144.3.7.1 GATE description

Figure 144-18 – GATE MPCPDU

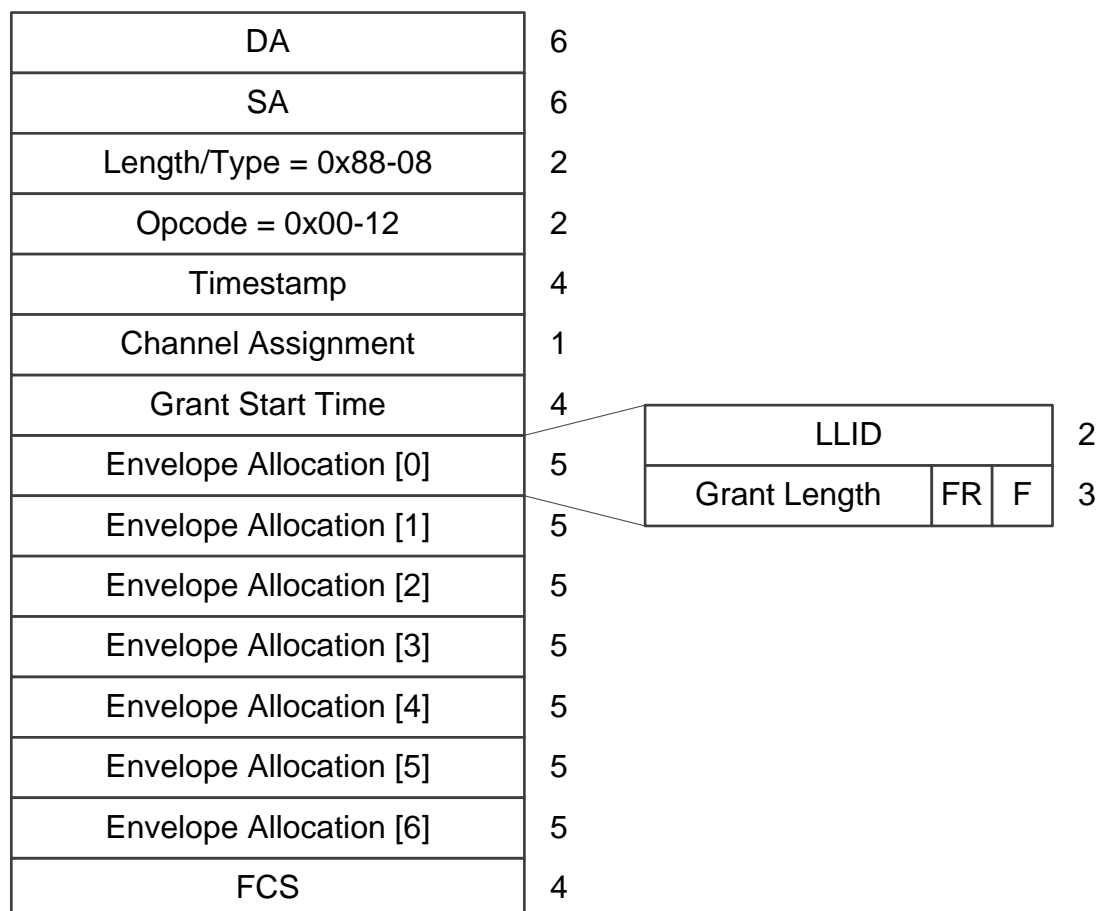
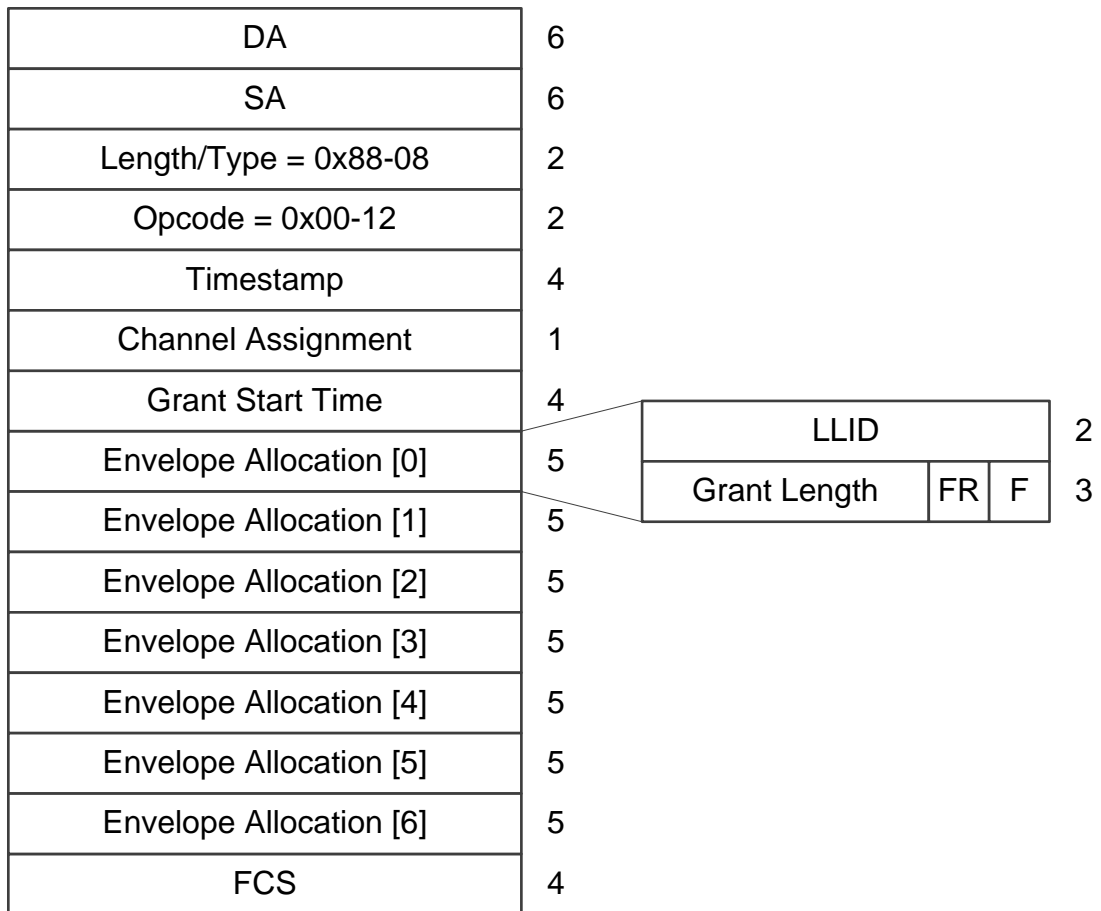
The purpose of GATE message is to grant transmission windows to ONUs for normal-upstream transmission on the shared medium. A single grant to an ONU may consist of multiple GATE MPCPDUs, all having the same Grant Start Time value. Up to seven grants-envelope allocations can be included in a single GATE MPCPDU (see Figure 144-18). Only grants-envelope allocations with non-zero value within the Grant Length LLID-#n field are processed by the ONU. A GATE MPCPDU with no Envelope Allocations (i.e., all LLID fields equal to zero) is valid and If the number of grants with non-zero value in the Grant Length-#n field in the GATE MPCPDU is zero, such a GATE MPCPDU is used as an MPCP keep alive from the OLT to the ONU.

- a) *Opcode*: The opcode for the GATE MPCPDU is 0x0012.
- b) *Channel Assignment*: This 8-bit flag register, where bits 0-3 contain a bitmap representing the wavelength-upstream channel(s) granted to the ONU. on which to

~~transmit on during the assigned transmission slot.~~ Bits 4-7 are reserved. Table 144-1 shows the mapping between individual bits and upstream channels. When multiple channels are assigned, a transmission on each channel shall start at Grant Start Time and shall have the length as necessary to transmit all allocated envelopes together with the associated optical and FEC overhead.

- c) *Grant Start Time*: This 32-bit unsigned integer value represents the start time of the transmission ~~grant~~window (burst), expressed in the units of 1-EQ. The start time is compared to the local clock, to correlate the start of the grant.

- d) *Envelope Allocation* is a 40-bit structure that describes the transmission window assigned to a specific LLID. Up to 7 envelope allocations may be included into a single GATE MPCPDU. The Envelope Allocation structure consists of the following sub-fields:

- i. *LLID-#n*: This 16-bit unsigned integer value represents the logical link that is being ~~granted-allocated~~ a transmission slot. The value of 0 in this field signifies an empty Envelope Allocation structure that shall be skipped over by the parser.

- ii. *Grant-Envelope Length-#n*: This 22-bit unsigned value represents the length of the ~~grant-envelope~~ assigned to this specific LLID-#n. The length of the ~~granted transmission slot~~envelope is expressed in the units of 1-EQ. Up to 7 grants may be packed into a single GATE MPCPDU. The Envelope Length represents the number of EQs to be sourced from a corresponding (virtual) MAC, less one EQ reserved for the Envelope Header. The Envelope Length does not include any transmission overhead components. All transmission overhead components (see TBD) are included in and thus consume part of the granted transmission slot.

- iii. *Fragmentation (F)*: ~~(TBD)~~This frag informs the ONU whether it is allowed to fragment new frames transmitted on the given LLID. If a frame fragment remains queued in this LLID since previous envelope transmission, this fragment is transmitted first, regardless of the value of the Fragmentation flag.

- iv. *Forced Report (FR)*: When the respective bit is set to 0, no action is required from the ONU. When the respective bit is set to 1, the ONU shall report the total length of the frames (including IPG and preamble), queued for transmission on this specific LLID, should issue a REPORT MPCPDU during the transmission grant indicated by the Grant Length #n field associated with this Forced Report flag.

- e) *Pad/Reserved*. This is an empty field that is transmitted as zeros, and ignored on reception. The size of this field depends on the ~~used-number of used Envelope Allocations Grant Length #n / LLID #n entry pairs as well as the presence of any optional fields,~~ and varies in length from 0- to 30-35 octets accordingly.

The purpose of GATE message is to grant transmission windows to ONUs for upstream transmission on the shared medium. A single grant to an ONU may consist of multiple GATE MPCPDUs, all having the same Grant Start Time value. Up to seven envelope allocations can be included in a single GATE MPCPDU (see Figure 144-18). Only envelope allocations with non-zero value within the *LLID* field are processed by the ONU. A GATE MPCPDU with no Envelope Allocations (i.e., all LLID fields equal to zero) is valid and is used as an MPCP keep alive from the OLT to the ONU.

- Ⓕ) *Opcode*: The opcode for the GATE MPCPDU is 0x0012.
- Ⓖ) *Channel Assignment*: This 8-bit flag register, where bits 0-3 contain a bitmap representing the upstream channel(s) granted to the ONU. Bits 4-7 are reserved. Table 144–1 shows the mapping between individual bits and upstream channels. When multiple channels are assigned, a transmission on each channel shall start at Grant Start Time and shall have the length as necessary to transmit all allocated envelopes together with the associated optical and FEC overhead.

- Ⓕ) *Grant Start Time*: This 32-bit unsigned integer value represents the start time of the transmission window (burst), expressed in the units of EQ. The start time is compared to the local clock, to correlate the start of the grant.

- Ⓖ) *Envelope Allocation* is a 40-bit structure that describes the transmission window assigned to a specific LLID. Up to 7 envelope allocations may be included into a single GATE MPCPDU. The Envelope Allocation structure consists of the following sub-fields:

- v. *LLID*: This 16-bit unsigned integer value represents the logical link that is being allocated a transmission slot. The value of 0 in this field signifies an empty Envelope Allocation structure that shall be skipped over by the parser.

- vi. *Envelope Length*: This 22-bit unsigned value represents the length of the envelope assigned to this specific LLID. The length of the envelope is expressed in the units of EQ. The Envelope Length represents the number of EQs to be sourced from a corresponding (virtual) MAC, less one EQ reserved for the Envelope Header. The Envelope Length does not include any transmission overhead components.

- vii. *Fragmentation (F)*: This frag informs the ONU whether it is allowed to fragment new frames transmitted on the given LLID. If a frame fragment remains queued in this LLID since previous envelope transmission, this fragment is transmitted first, regardless of the value of the Fragmentation flag.

- viii. *Forced Report (FR)*: When the respective bit is set to 0, no action is required from the ONU. When the respective bit is set to 1, the ONU shall report the total length of the frames (including IPG and preamble), queued for transmission on this specific LLID.

- Ⓕ) *Pad/Reserved*. This is an empty field that is transmitted as zeros, and ignored on reception. The size of this field depends on the number of used Envelope Allocations and varies in length from 0 to 35 octets.
